Detailed Site Plan
Departure from Design Standards
Alternative Compliance
The Herman Apartments

DSP-22017
DDS-24003
AC-25009

STAFF REPORT

SUBJECT: Detailed Site Plan DSP-22017
Departure from Design Standards DDS-24003
Alternative Compliance AC-25009
Type 2 Tree Conservation Plan TCP2-023-2025
Variance to Section 27-442(c)
The Herman Apartments

Figure 1: Site Plan

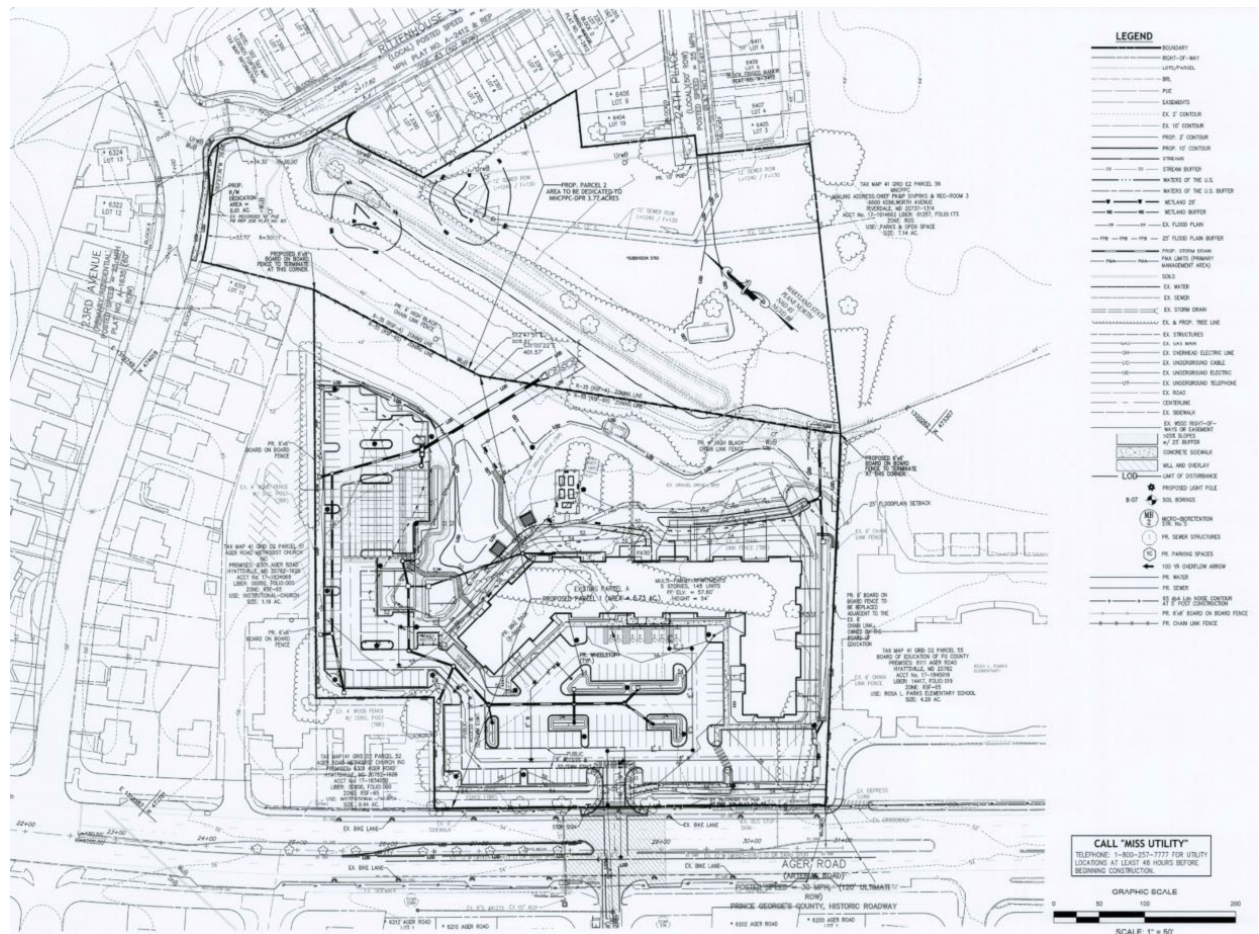
6. **Design Features:** The DSP proposes development of 145 multifamily dwelling units within one 5-story building, with one vehicular access driveway from Ager Road. The proposed multifamily building with associated infrastructure and amenities will be developed on the proposed Parcel 1. Proposed Parcel 2 will be dedicated to M-NCPPC, to add onto the stream valley parkland, located on abutting Heurich Park. Due to the existing environmental features on the northern portion of proposed Parcel 1, the proposed multifamily building on Parcel 1 will be located south of the 100-year floodplain and its buffer area, facing a parking area that will occupy the western and southern portions Parcel 1.

Figure 5: Floodplain acreage comparison with surrounding properties

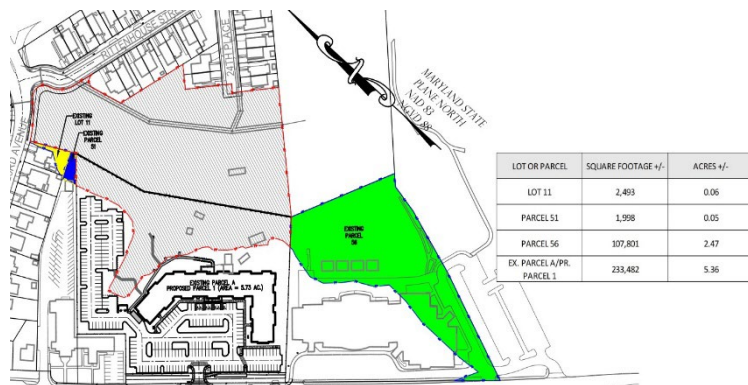
The applicant further provides a graphic showing the area of floodplain on the subject property (outlined in red), compared to the floodplain area on neighboring properties (shown in green, blue, and yellow).
